Technical Service Bulletin

No.LA419-003
11 October 2005

Subject/Concern: Discovery 3/LR3 - Accessory Phone System Fault

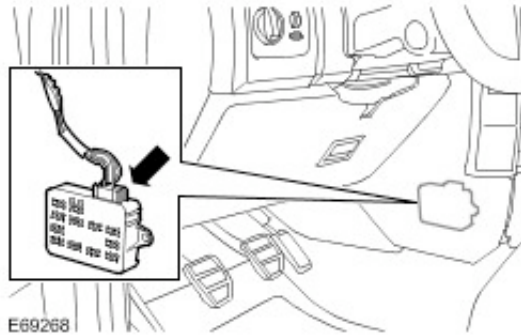
1. It will stop the present call being terminated when another call attempts to connect (call waiting).
2. When a call is ended the phone will not stay muted (currently requiring an ignition cycle to rectify the problem).
3. The red button will now cancel an unanswered call.
 - 1 . Release the cellular telephone module from the Velcro® retaining strips.

- 2 . Remove the cellular telephone module from behind the floor console. Refer to illustration in step 1.
- 3 . Disconnect the cellular telephone module electrical connector. Refer to illustration in step 1.
- 4 . Remove the cellular telephone module.
- 5 . Attach Velcro® strips to the new cellular telephone module.
- 6 . Position the cellular telephone module from behind the floor console.
- 7 . Attach the cellular telephone module to the Velcro® retaining strips.
